ISO/
IEC/IEEE
8802-3

AMENDMENT 1
2021-12

**AMENDMENT 1: Physical layer
specifications and management
parameters for 2.5 Gb/s and 5 Gb/s
operation over backplane**

Amendment 1: Physical Layer Specifications and Management Parameters for 2.5 Gb/s and 5 Gb/s Operation over Backplane

Figure 69-4—Architectural positioning of 2.5 Gb/s and 5 Gb/s Backplane Ethernet

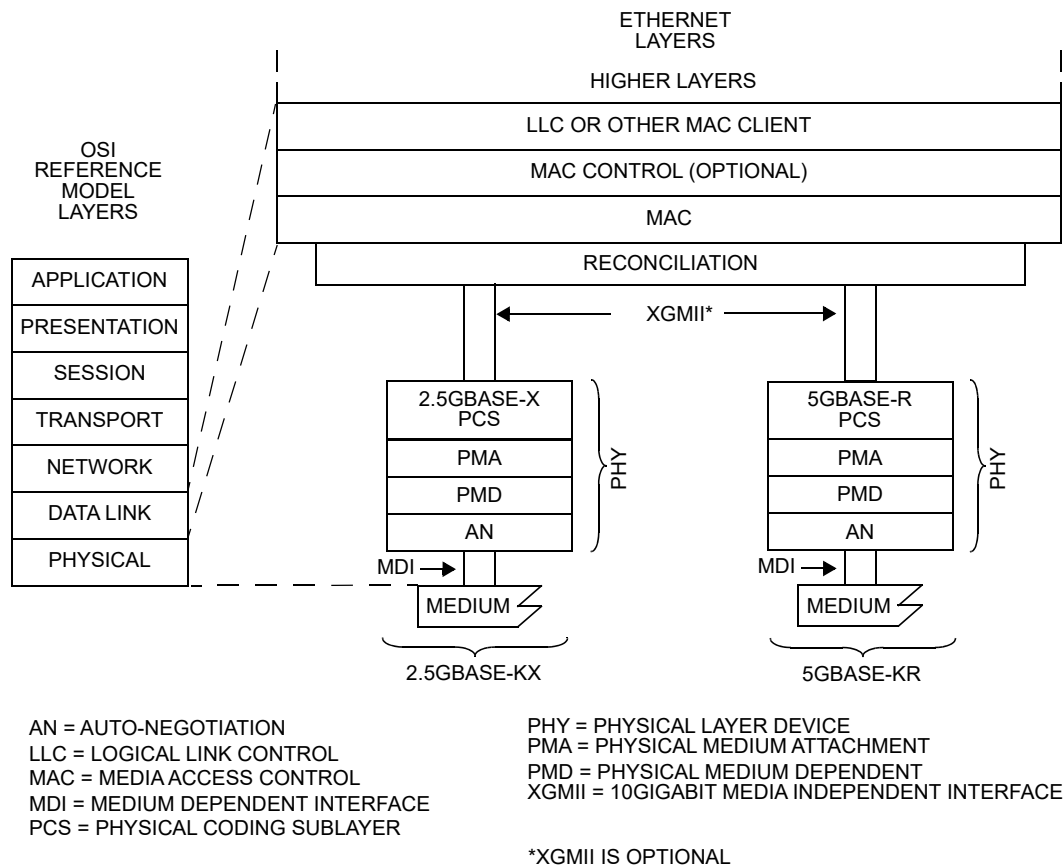
Backplane Ethernet couples the IEEE 802.3 MAC to a family of Physical Layers defined for operation over electrical backplanes. The relationships among Backplane Ethernet, the IEEE 802.3 MAC, and the ISO Open System Interconnection (OSI) reference model are shown in [Figure 69-1](#), [Figure 69-2](#), ~~and~~ [Figure 69-3](#), ~~and~~ [Figure 69-4](#).

Insert the new figure on the next page (Figure 69-4) after Figure 69-3.

Figure 73–1—Location of Auto-Negotiation function within the ISO/IEC OSI reference model

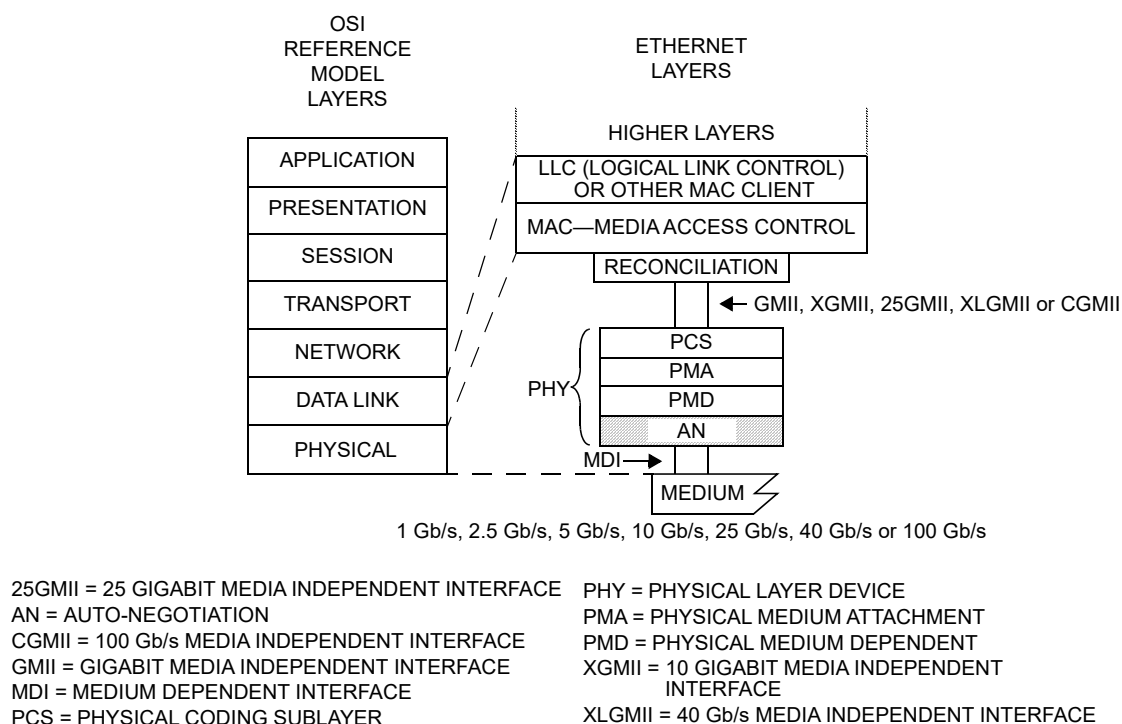
Replace Figure 73–1 with the following figure (which adds 2.5 Gb/s and 5 Gb/s in the medium rates):
